ADDENDUM #01

McHenry County Division of Transportation

Section 21-00527-00-RS

The following information shall be incorporated within the bid packet for McHenry County DOT
Section # 21-00527-00-RS:

TYPICAL SECTIONS

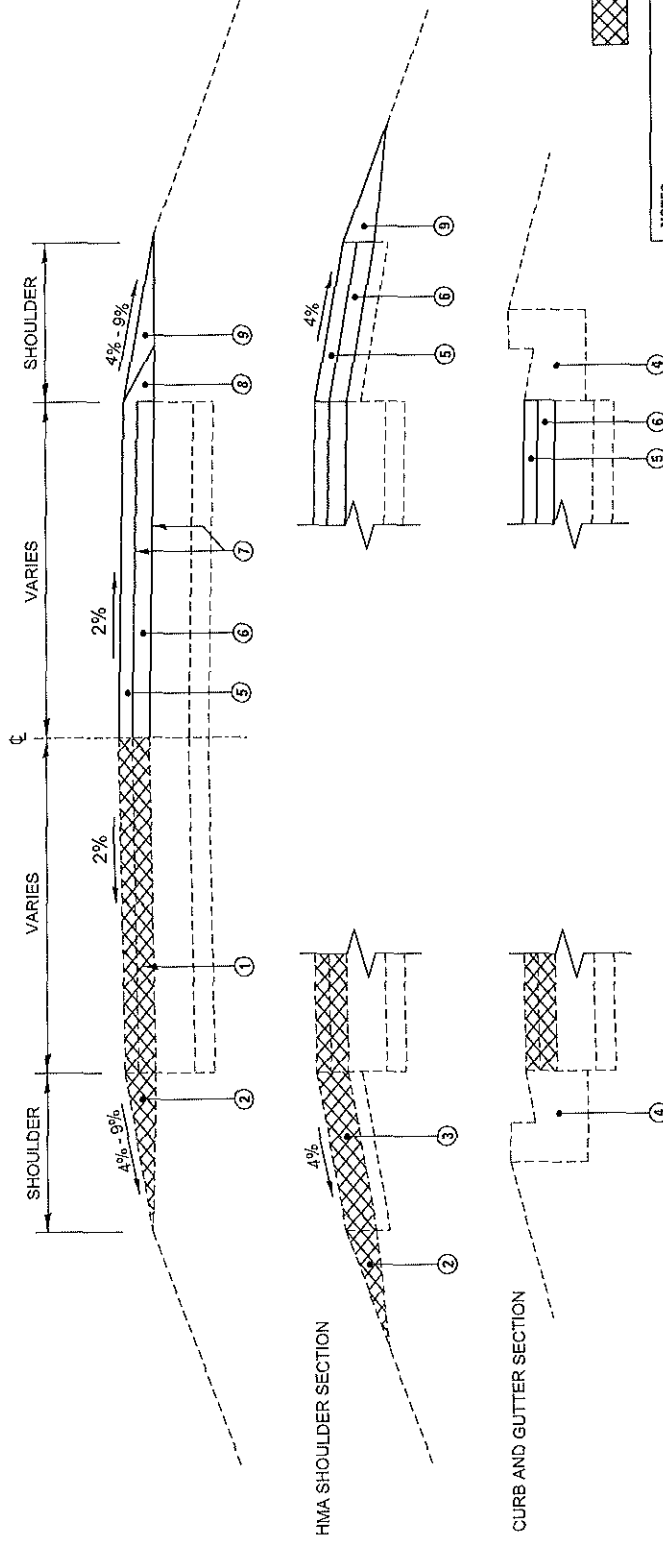
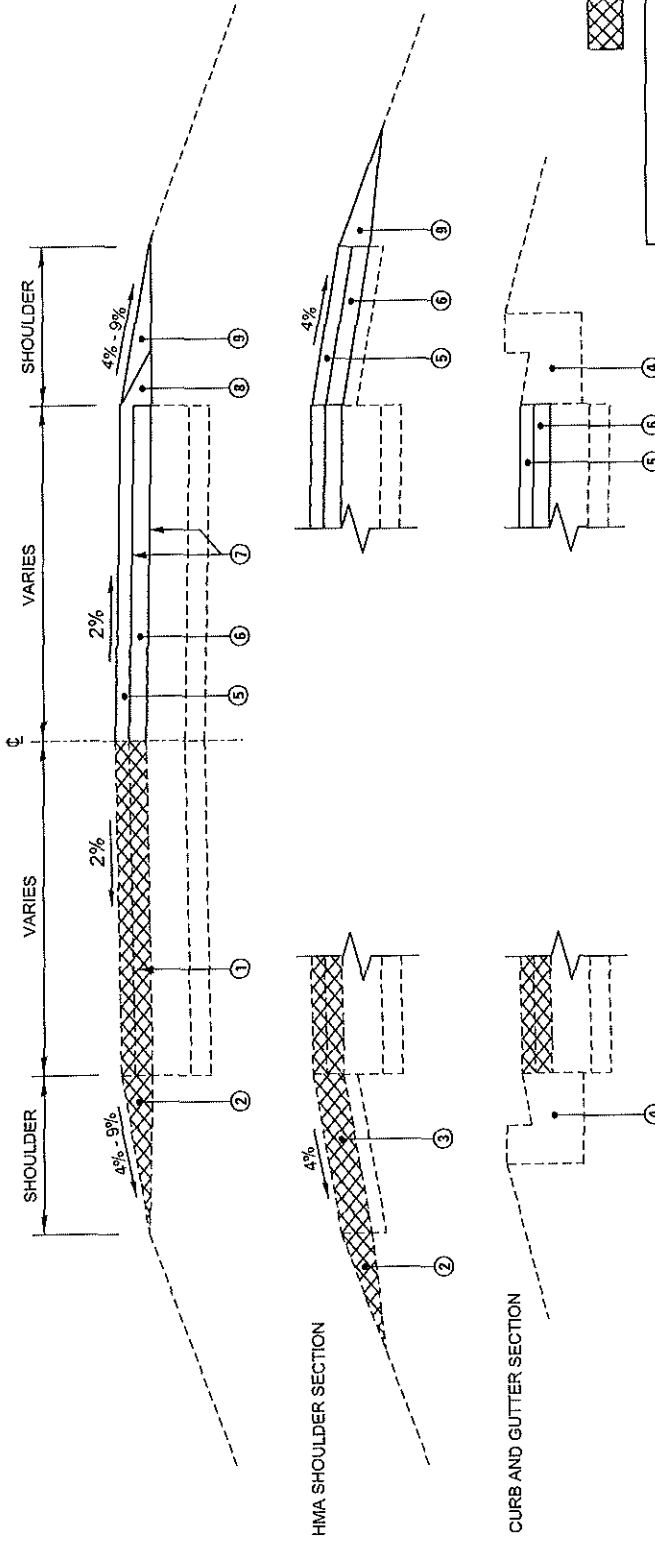
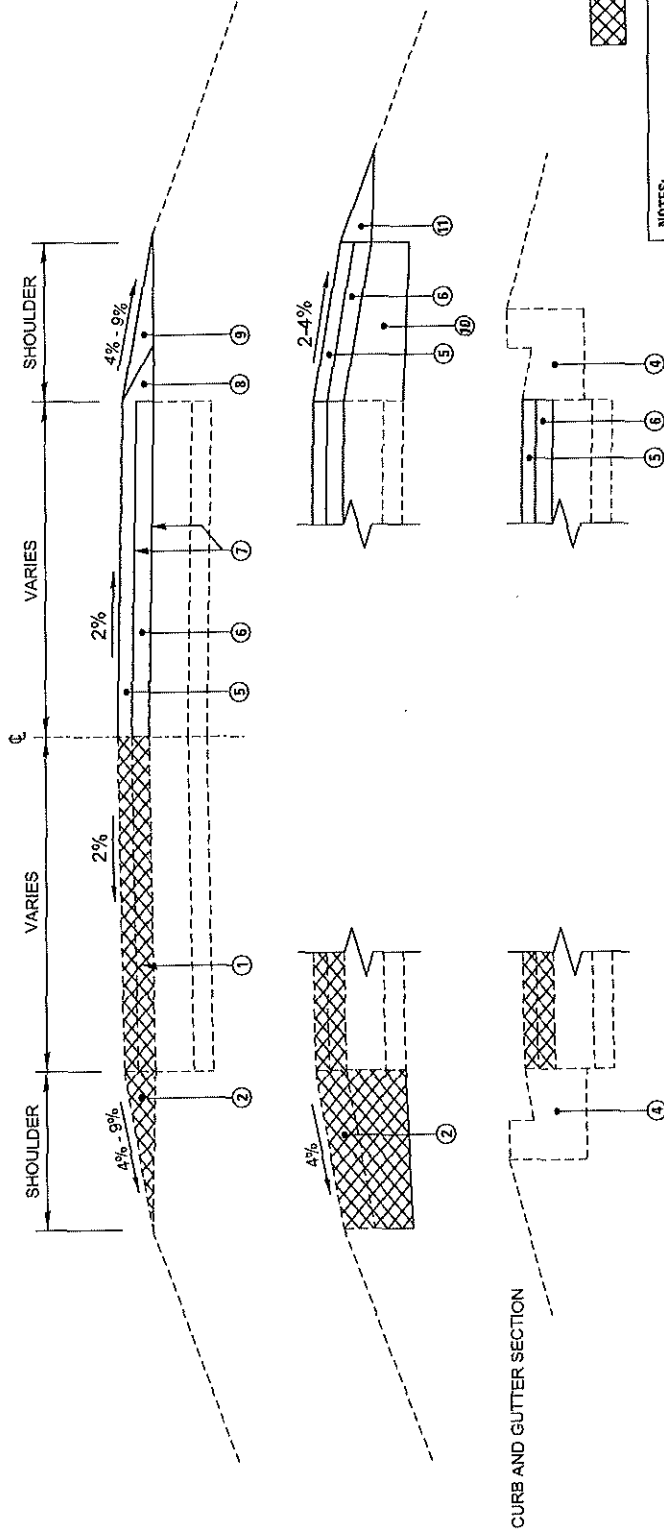
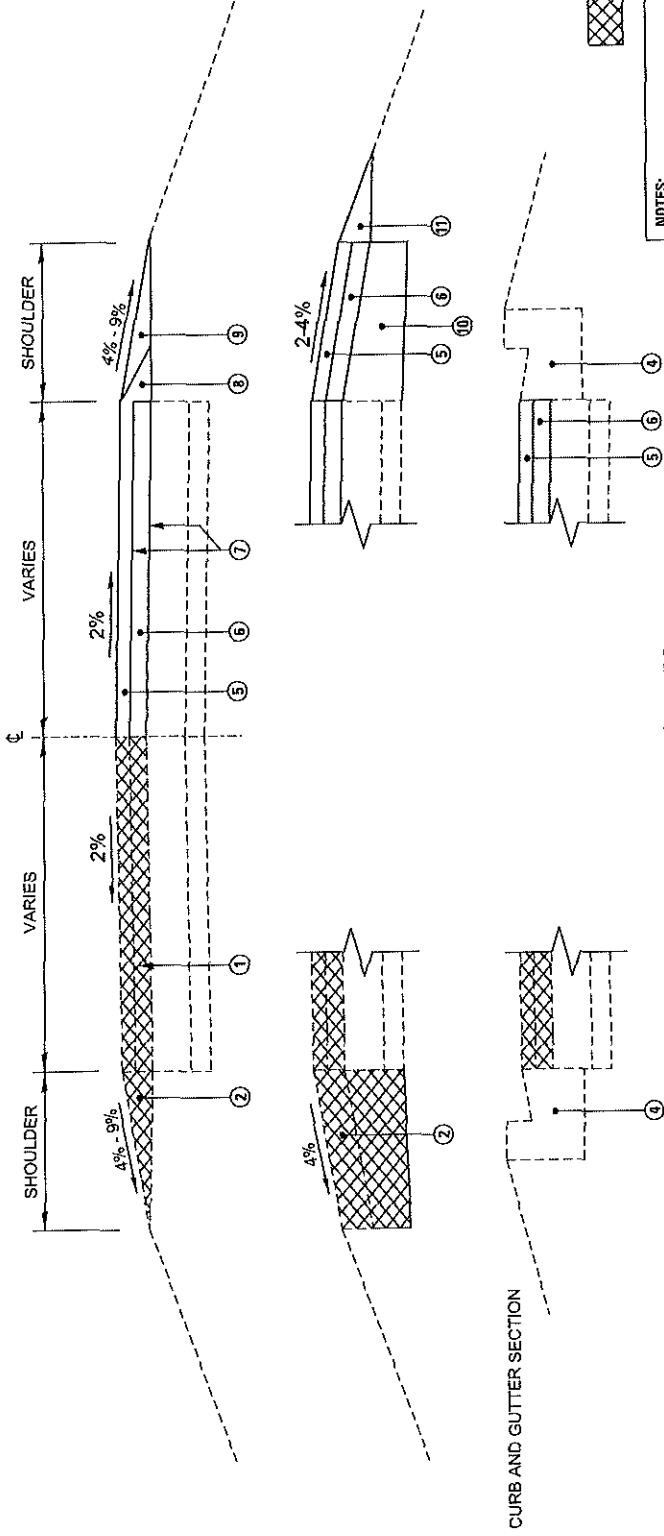
The attached Typical Sections shall replace the existing Typical Sections in the above Section # Proposal.

SAFETY EDGE DETAILS

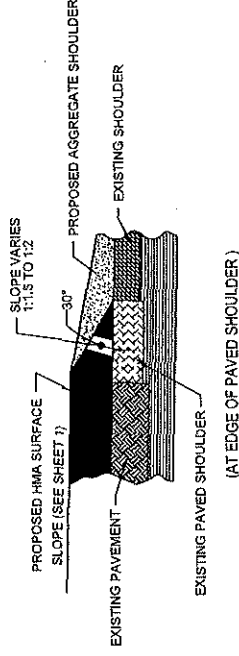
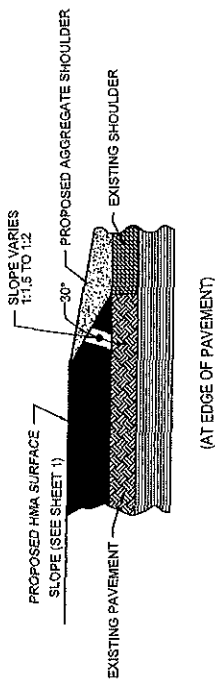
DESIGNED BY	DATE	REVISION / REMARKS	NO.	DESCRIPTION	CHECKED BY	DATE	BY	DATE	STATE OF ILLINOIS MCHENRY COUNTY DIVISION OF TRANSPORTATION	MCHENRY COUNTY RESURFACING TYPICAL SECTION	ROUTE	SECTION NUMBER	SHEET NO.	TOTAL SHEETS
			1	Revised Safety Edge Details		12/21/21						21-00527-00-RS	2	2

SAFETY EDGE TREATMENT SHALL BE APPLIED TO PAVED SHOULDER OF 1 FT OR LESS THAT IS ADJACENT TO AGGREGATE/EARTH SHOULDER.

ILLINOIS DEPARTMENT OF TRANSPORTATION
 ACKMAN ROAD (CH 42-A46) AT
 GOLF COURSE ROAD
 TRAFFIC SIGNAL IMPROVEMENTS

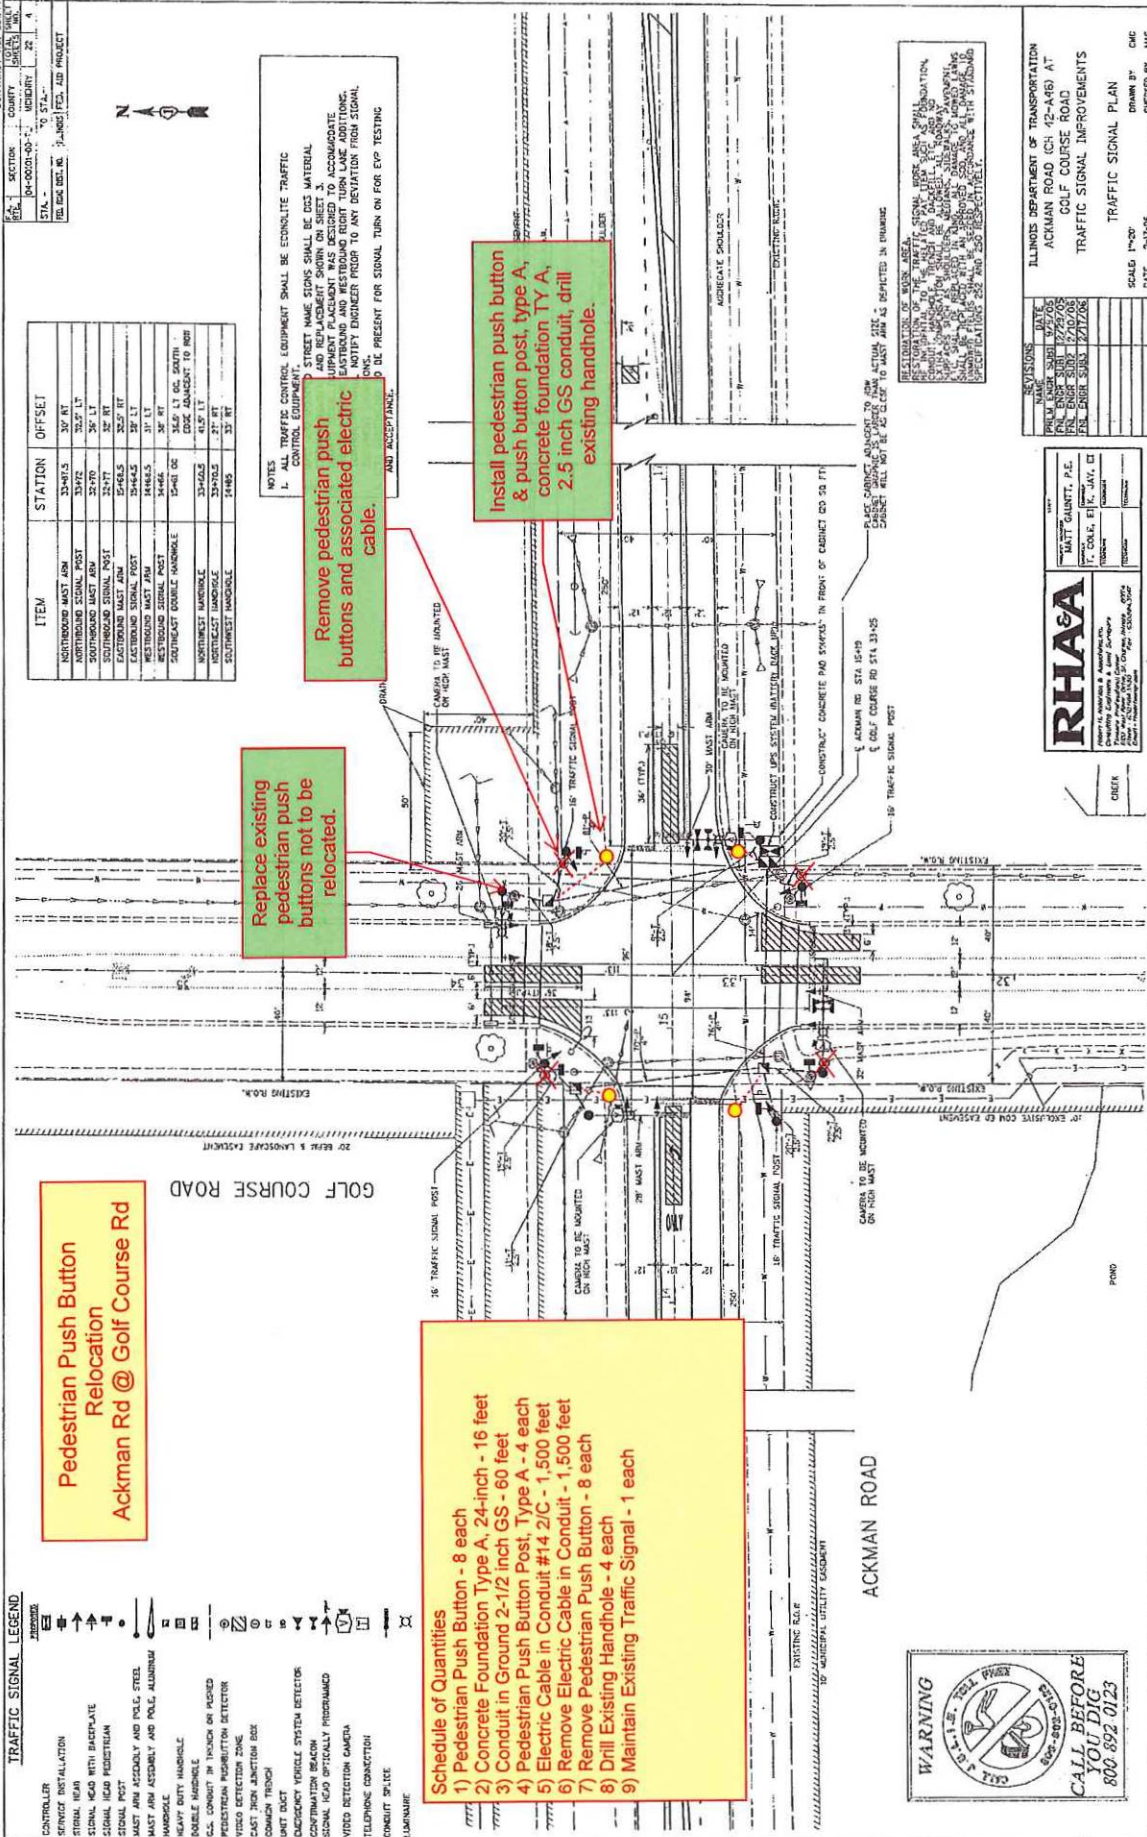
The attached Pedestrian Push Button Relocation pages shall be inserted into and be part of the above Section # Proposal.

Replace existing pedestrian push buttons not to be relocated.

Remove pedestrian push buttons and associated electric cable.

FLASHER RELOCATION

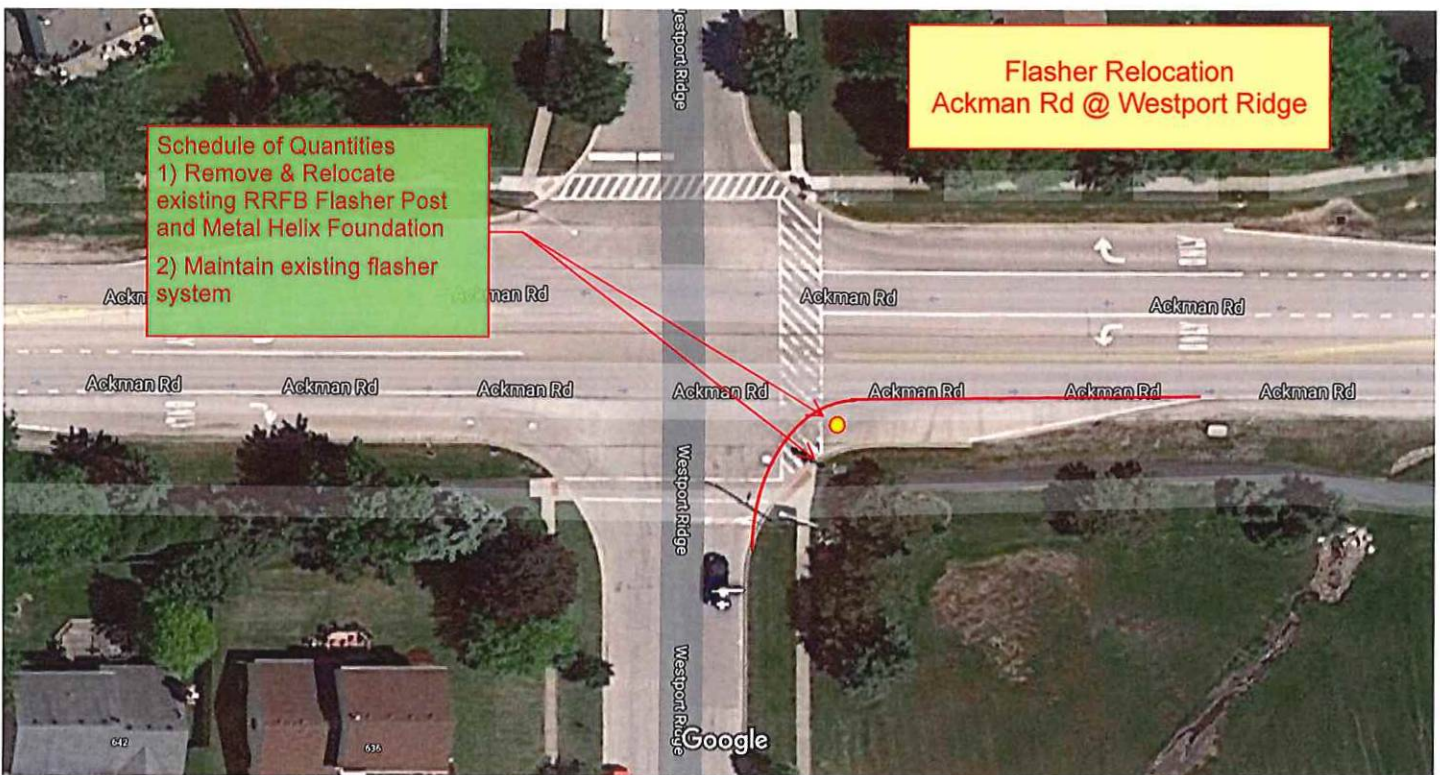
The attached Flasher Relocation page shall be inserted into and be part of the above Section # Proposal.
